## Engineering Review of the 'HS2 Tunnel Extension' Proposal by LBH for a Tunnel through the Colne Valley

## London West Midlands

Figure 4.2 from PBA Report

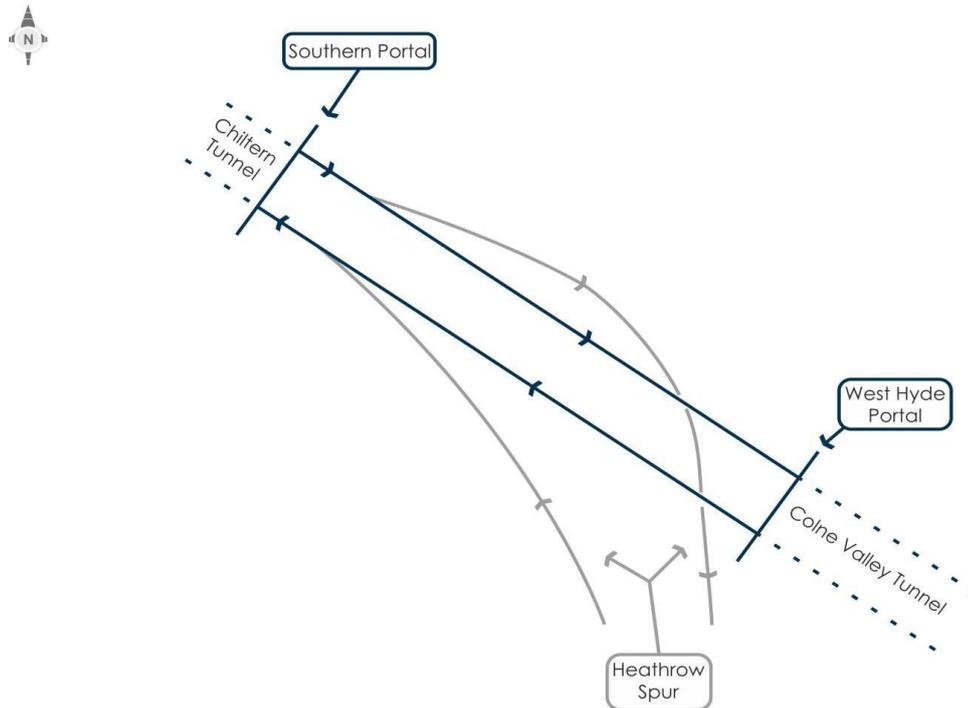
- 3.3.5 Launching the TBMs from the West Hyde/M25 location would provide an adequate works area and good access to major highway routes.
- 3.3.6 The Intervention Gap including passive provision for Heathrow spurs – This element of the Colne Valley Tunnel proposal would be approximately 1.6 km long and up to 50 m deep. The PBA proposal provides little detail regarding the potential layout of the Intervention Gap. The figure below from the PBA proposal provides a suggested layout for the gap structure.

- 3.3.7 As the spurs are to be constructed after the mainline, this proposed layout would require a bridge/tunnel to be built within the gap that would pass through the retaining wall structure. Both spurs would have to be extended to a distance away that would allow the remaining spurs to be constructed and connected without disrupting mainline operations. This arrangement would substantially increase the size of the final structure at the Intervention Gap, increasing cost, excavated material removal, and construction programme for the CVT.

- 3.3.8 If the spurs were constructed to enter the southern headwall of the Intervention Gap and then tunnelled over or under the mainline, the Intervention Gap excavation would be reduced. As no specific layout was specified in the PBA report, this layout was assessed for constructability as it minimized the excavation required.

Figure B2 from PBA Proposal

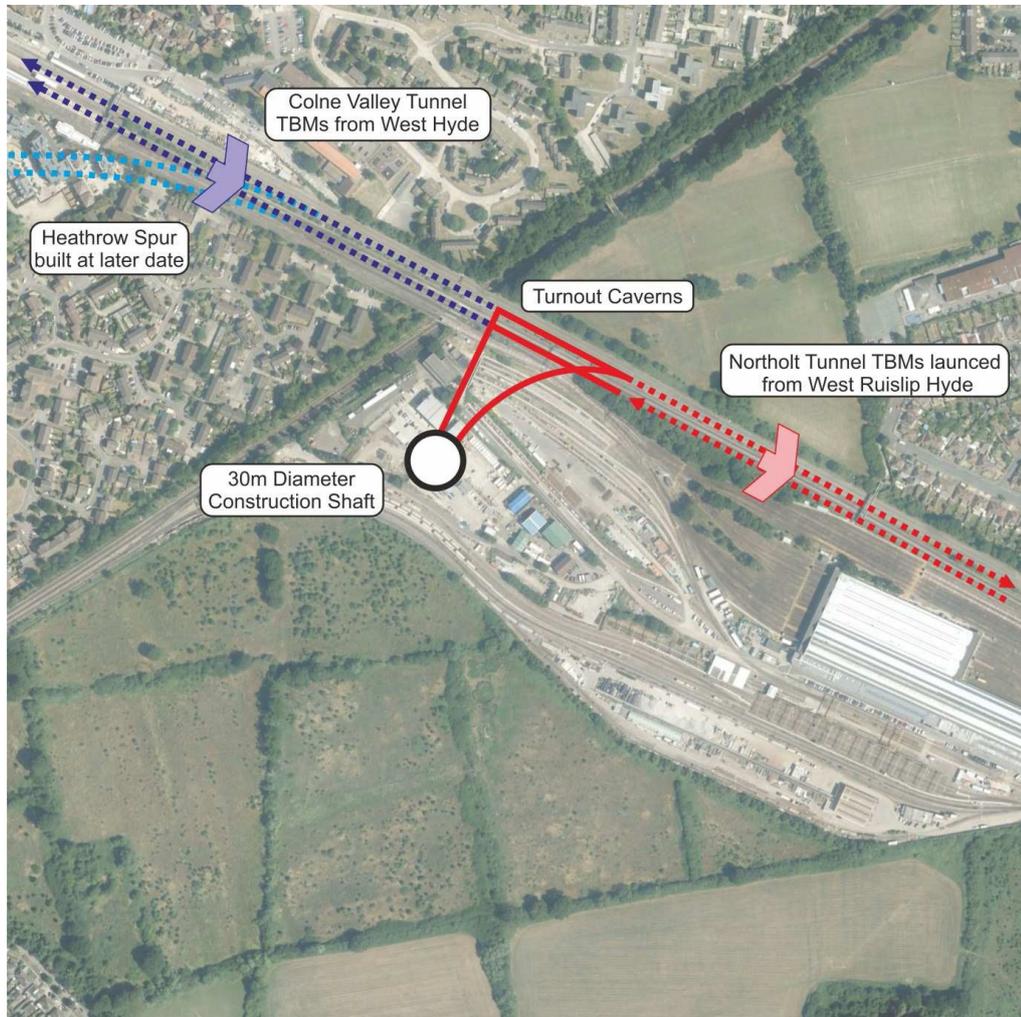
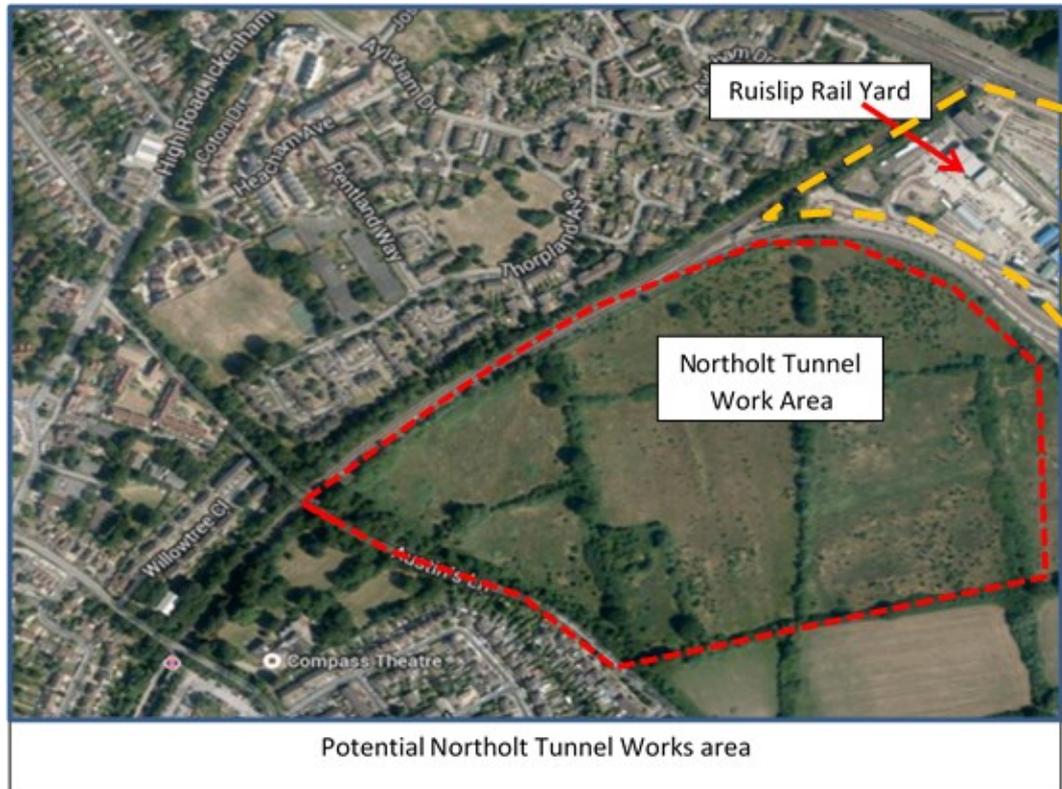
- 3.3.19 The PBA proposal would substantially impact the Ruislip rail depot and its operations. The PBA proposal locates the shaft in the middle of the rail depot. See figure below.

- 3.3.24 As figure B2 above indicates, the PBA proposal also proposes that passive provision for London facing Heathrow spurs are included as part of this structure. As part of incorporating the passive provision for the spurs at this location, a grade separation alignment is proposed to accommodate the spur

passing under the mainline track. No specific details regarding the internal geometry required to accommodate the above constraints have been provided and therefore a number of assumptions have been made to assess this element of the PBA proposal.
